RENESAS TECHNICAL UPDATE

Product Category	MPU/MCU		Document No.	TN-RA*-A0152A/E	Rev.	1.00
Title	Note about the interruption during the transition to low power modes		Information Category	Technical Notification		
Applicable Product	RA8M1, RA8D1, RA8T1, RA8E1, and RA8E2 Group	Lot No.	Reference Document	Refer table at the end of this document		
		All

1. Correction of the Figure10.1 “Mode transitions”

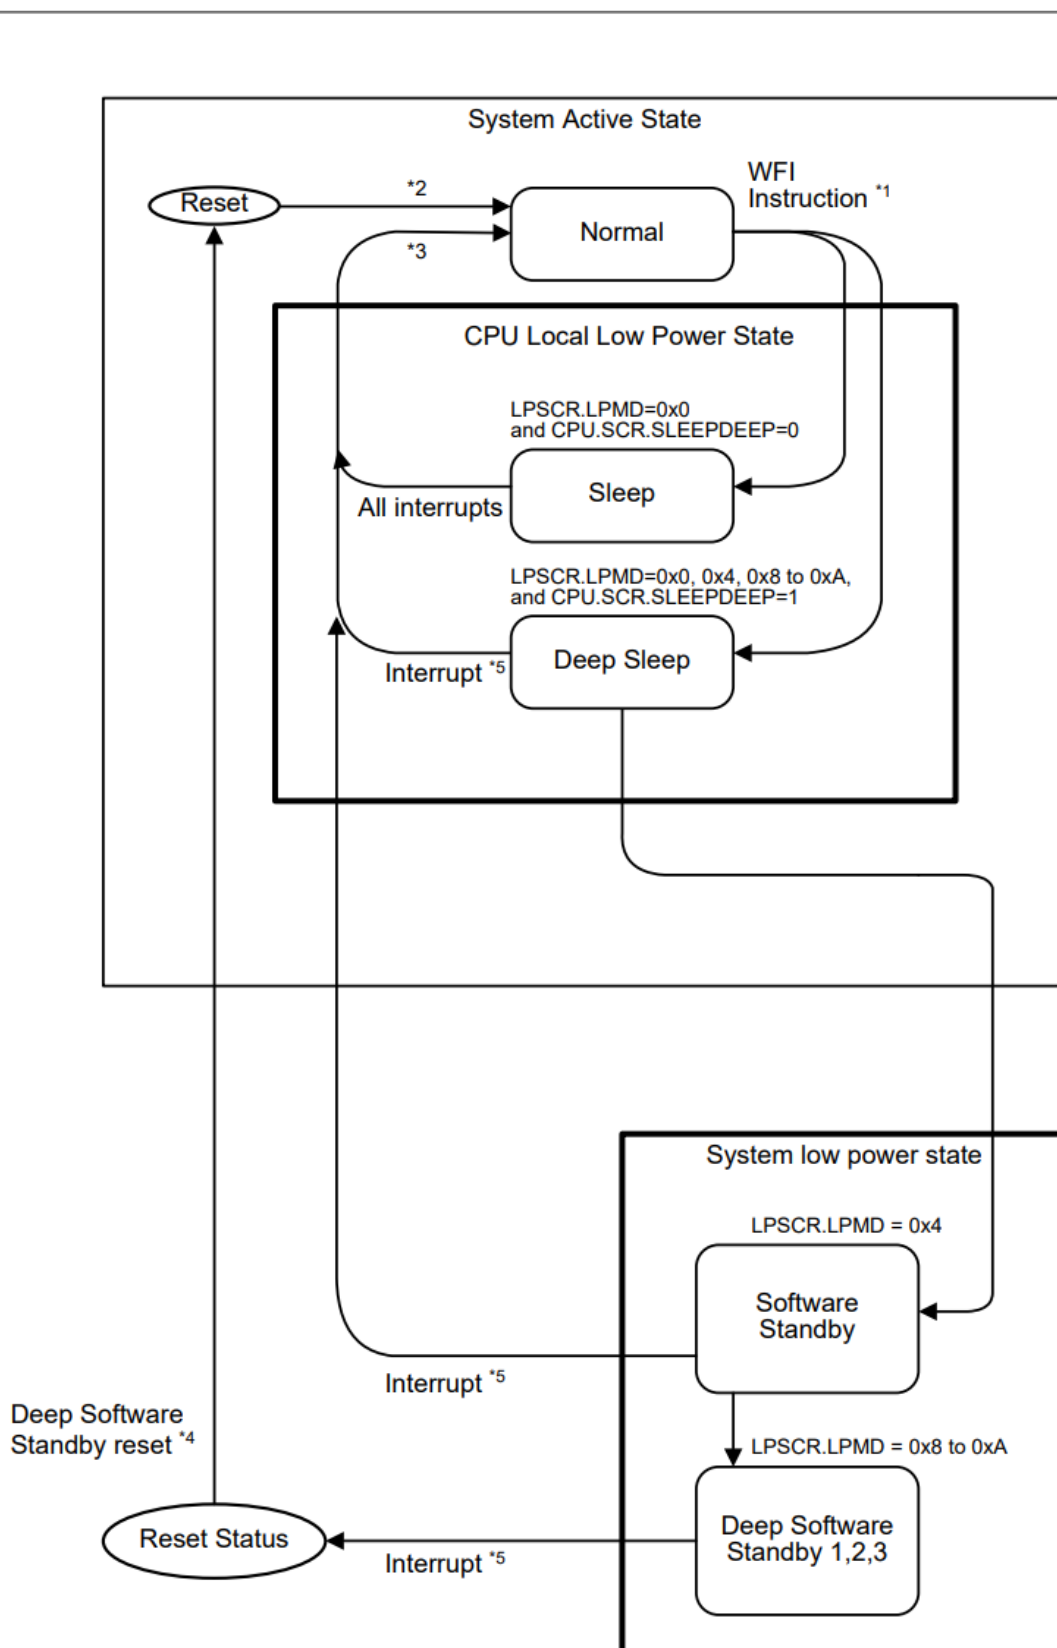
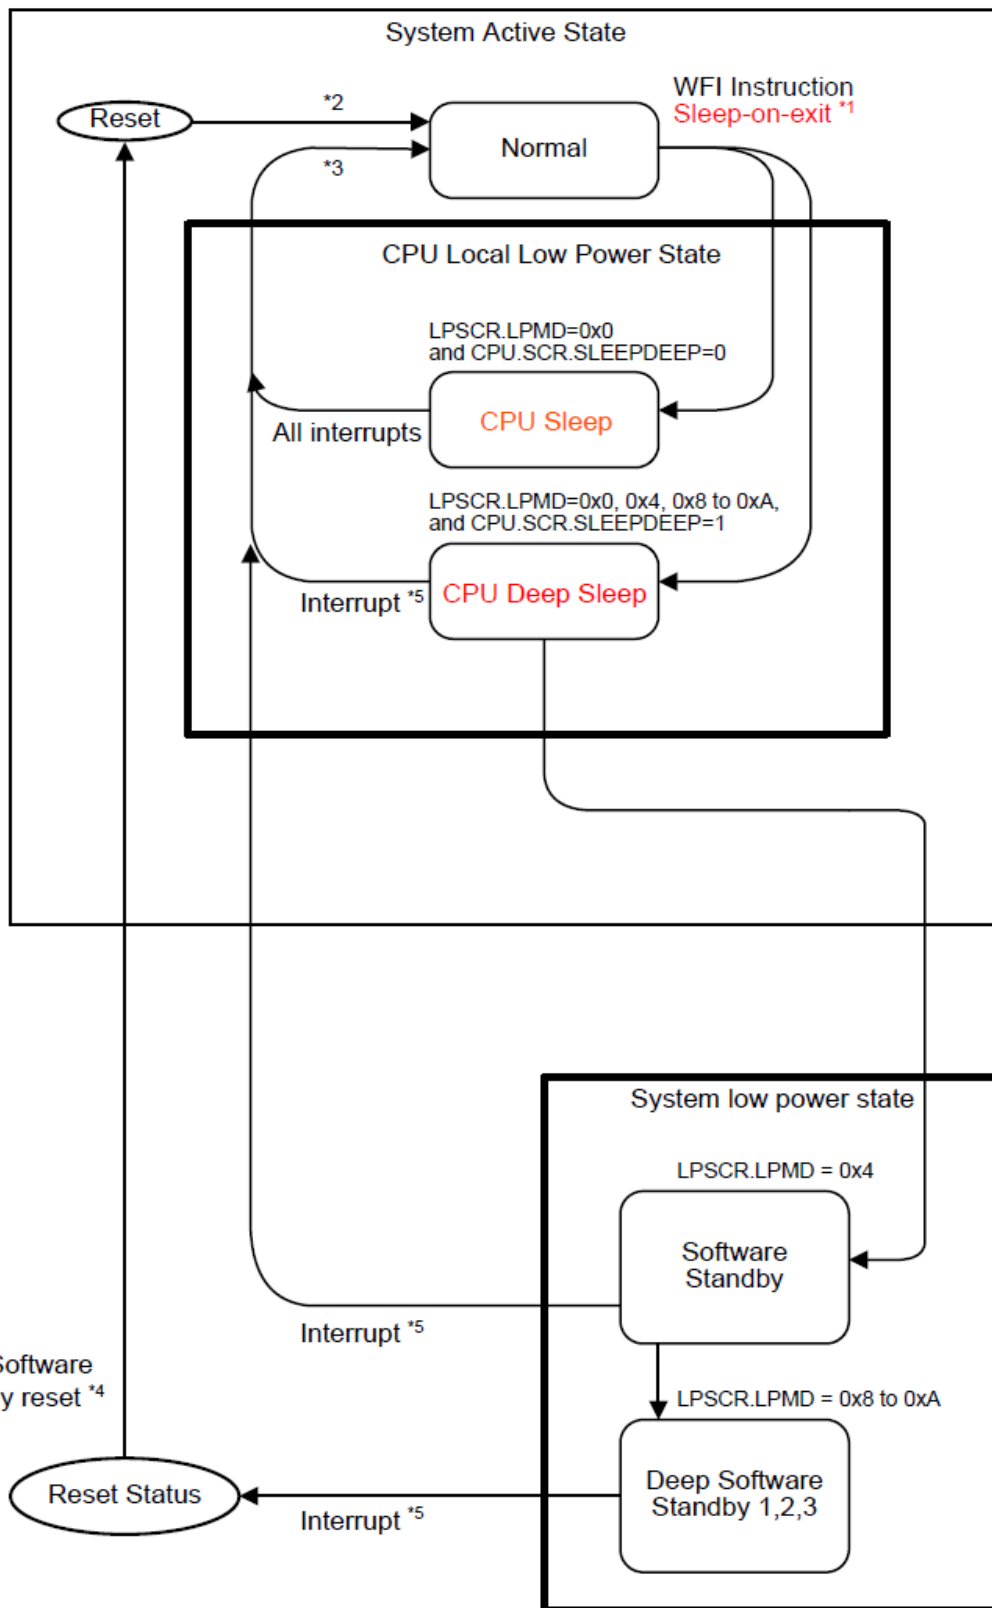
Before correction

Note 1. When an interrupt as a trigger for cancel is received during a transition to the program-stopped state after the execution of a WFI instruction, the MCU executes interrupt exception handling instead of transitioning to low power mode. When entering to Deep Software Standby mode, if an interrupt occurs after the state has transitioned, after mode transition is completed, returning with Deep Software Standby reset.

After correction

Note 1. When an interrupt that acts as a trigger for cancellation of CPU Sleep mode state is received during a transition to the CPU Sleep mode state or CPU Deep Sleep mode state, the MCU does not transit to CPU Sleep mode state or CPU Deep Sleep mode state but goes back to Normal mode state.
